Well Name: BOIS D` ARC DIVIDE 22	Well Location: T21N / R5W / SEC 22 / SESW / 36.0297272 / -107.3533081	County or Parish/State: SANDOVAL / NM
Well Number: 1	Type of Well: CONVENTIONAL GAS WELL	Allottee or Tribe Name:
Lease Number: NMNM105533	Unit or CA Name:	Unit or CA Number:
US Well Number: 3004320952	Well Status: Producing Gas Well	Operator: EOG RESOURCES INCORPORATED

Notice of Intent

Sundry ID: 2714944

Plug And Abandonment Procedure

Proposed Wellbore Diagram

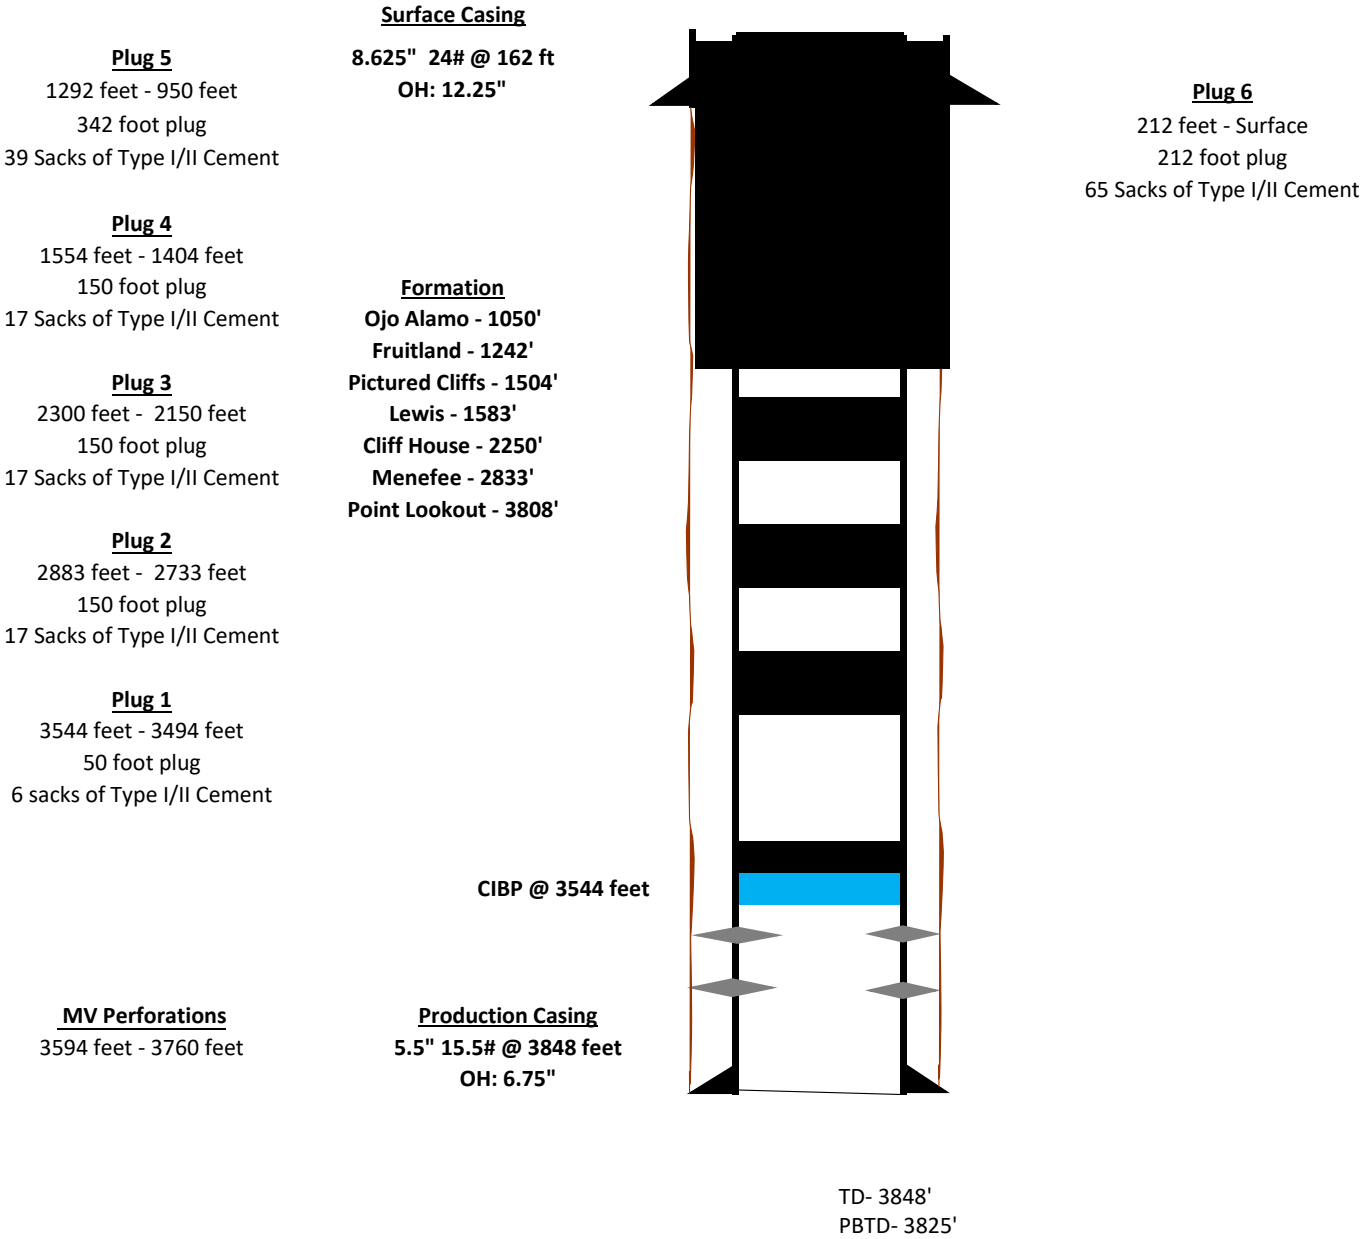
You are also required to place cement excesses per 4.2 and 4.4 of the attached General Requirements.
